SUBJECT: DRAFT SAFETY EVALUATION FOR TOPICAL REPORT WCAP-15836-P,
"FUEL ROD DESIGN METHODS FOR BOILING WATER REACTORS -
SUPPLEMENT 1" (TAC NO. MB5740)

DRAFT SAFETY EVALUATION BY THE OFFICE OF NUCLEAR REACTOR REGULATION

TOPICAL REPORT WCAP-15836-P, "FUEL ROD DESIGN METHODS

FOR BOILING WATER REACTORS - SUPPLEMENT 1"

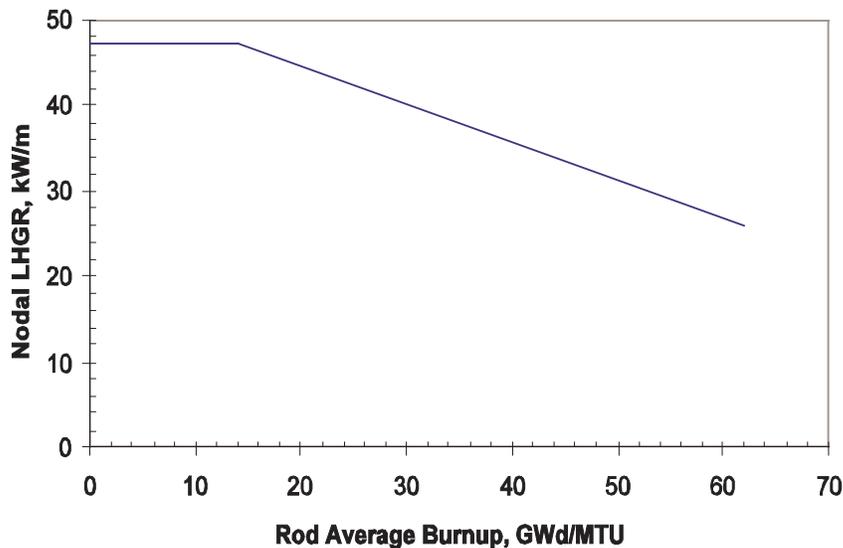
11 must meet the LHGR versus time duration used for analyzing AOO events. Based upon the
12 information presented in Reference 5 along with the PNNL technical assessment, the NRC staff
13 finds that STAV7.2 is applicable up to the nodal power profile depicted below.
14

15 The figure below illustrates the peak LHGR ≤ 47.3 kW/m from BOL to a rod average burnup of
16 14 GWd/MTU, then linearly decreasing to 26 kW/m at a rod average burnup of 62 GWd/MTU.
